Liz Fashion Industry Ltd. (#9640)

Zamirdia (Steel Store), P.S. –Bhaluka, Mymensingh

14.MAY.2014

Identified Priority 2 Concerns

1st Priority 2 Concern

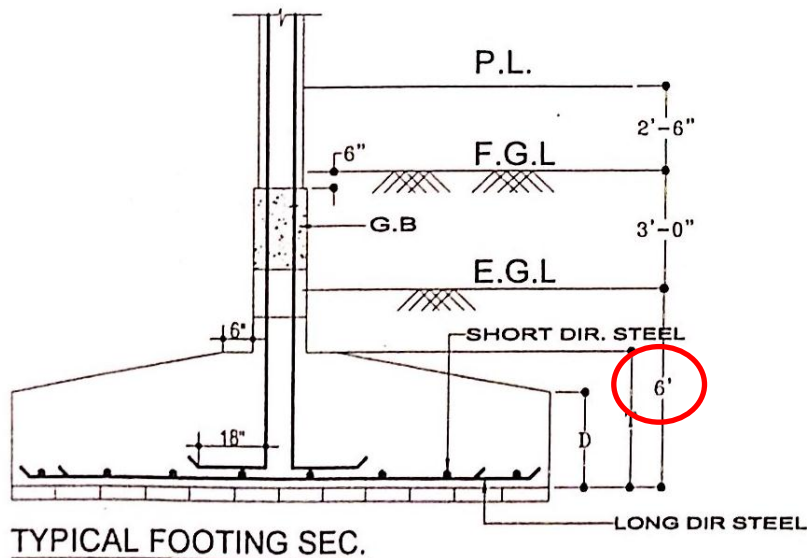
Foundation depth on structural drawings does not meet recommendations from soils report.

Foundation depth on drawing = 6'0"
Foundation depth on soils report = 9'0"

Item No.	Observation	Recommended Action Plan	Recommended Timeline
1	Foundation depth on structural drawings does not meet recommendations from soils report.	Complete a soils investigation, at the depth of the existing footings, to determine the actual bearing capacity before constructing more than 4 storeys.	6-weeks
2	Foundation depth on structural drawings does not meet recommendations from soils report.	Consider recommendations from soils report when designing additional storeys.	6-months
